Before a Board of Inquiry
Transmission Gully
Notices of Requirement and Consents

Second statement of rebuttal evidence of Craig Murray Martell (Hydrology)
for the NZ Transport Agency and Porirua City Council

Dated: 16 February 2012

Figure 4 – Pauatahanui Stream: Observed and Simulated Average Daily Flows

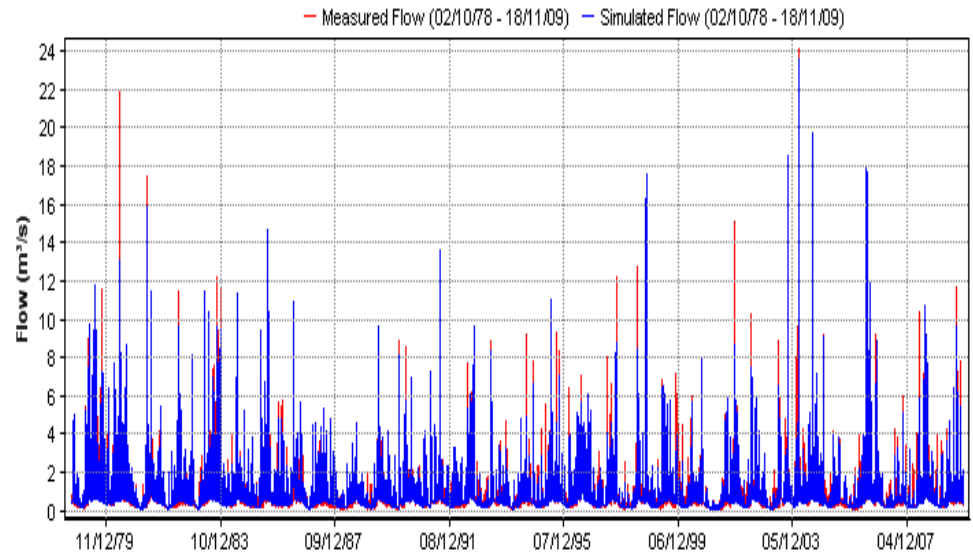
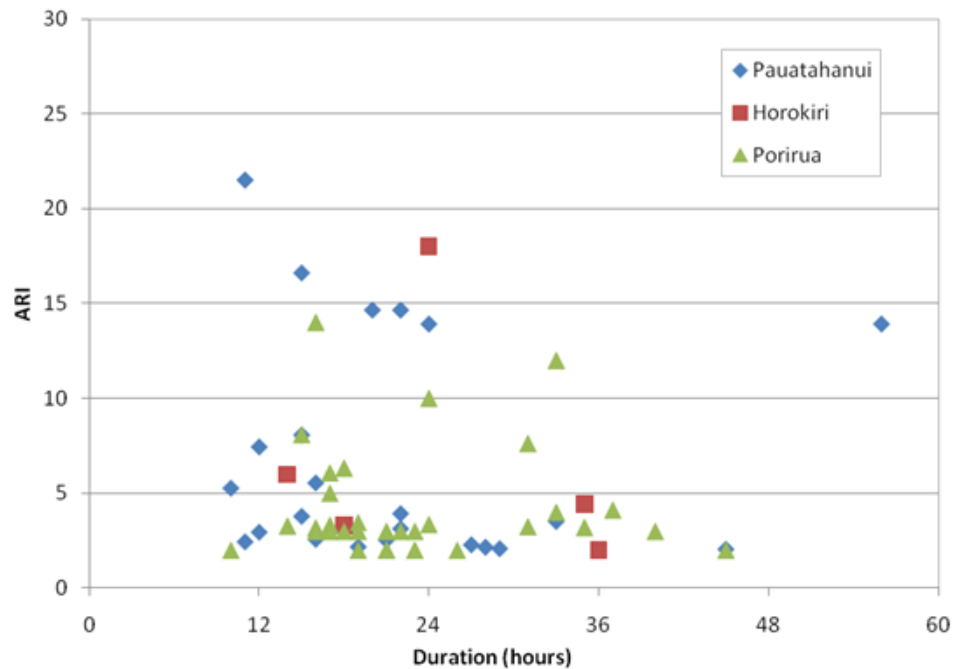
- 16 In the first paragraph of page 16 of his section 42A report, Dr Hicks has questioned the calibration methodology for the SMWB Model.
- 17 While not the author or reviewer of Technical Report 15 I am comfortable that the appropriate approach has been taken as the intention of this model was to provide the basis for a long term simulation into the harbour, with calibration across the full range of flows being important. The match shown for the Horokiri stream is typical of the variation that is found when viewing a calibrated model against real data. This occurs due to the fact that assumptions made in the simulation, such as even rainfall distribution across the catchment, and rainfall depths for a specific event, may not match what occurred in reality. If the Horokiri

stream record had been longer, I would expect a more even distribution of “unders and overs” and this can be seen in the longer calibrated record for the Pauatahanui stream (**Figure 4** below).
